BID ADDENDUM NO. 5

October 08, 2018

Johnson Student Center Building Demolition, Increment 1 (Demolition) and Increment 2

RANCHO SANTIAGO COMMUNITY COLLEGE DISTRICT
SANTA ANA, CA

3 FIRST FLOOR BDF ROOM
SCALE: 1/4" = 1'-0"

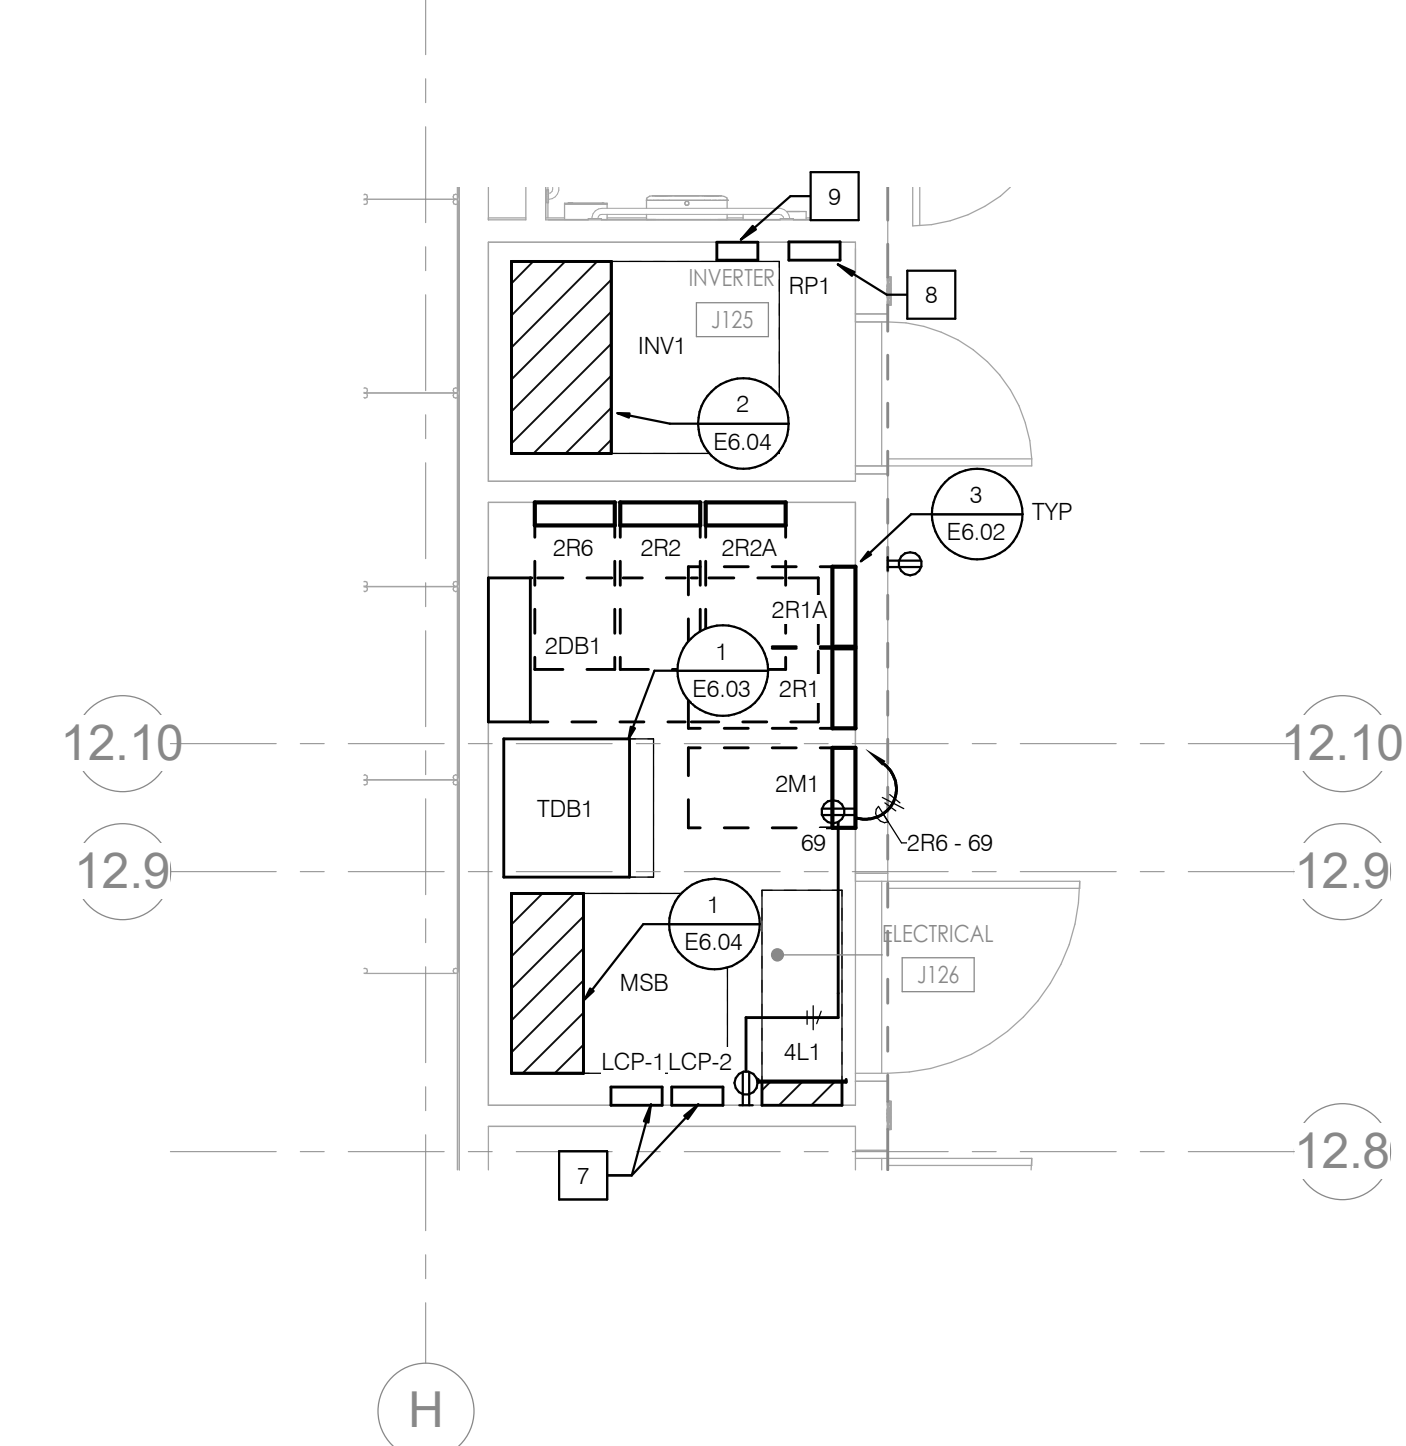
DATE:	09/27/2018		
FROM:	S.Monsen - McCarthy	EMAIL:	SMonsen@McCarthy.com
SPECIFICATION NUMBER:	E0.10	DRAWING NUMBER:	
REQUESTED CLARIFICATION:			
Increment #2 - Panelboard "4M" on drawing E0.10 is missing required amperage, main breaker or main lug size and missing required quantity and sizes of branch circuit breakers. Please advise what will be required.			
RESPONSE TO CLARIFICATION, SUBMITTED AS PART OF AN ADDENDUM:			
Panelboard 4M was shown with a distribution board schedule. Refer to Addendum #5 for revised schedule including all information.			
Melissa Klug, P2S 10/1/18			
RESPONSE PROVIDED BY:	Melissa Klug / P2s	DATE:	10/08/18
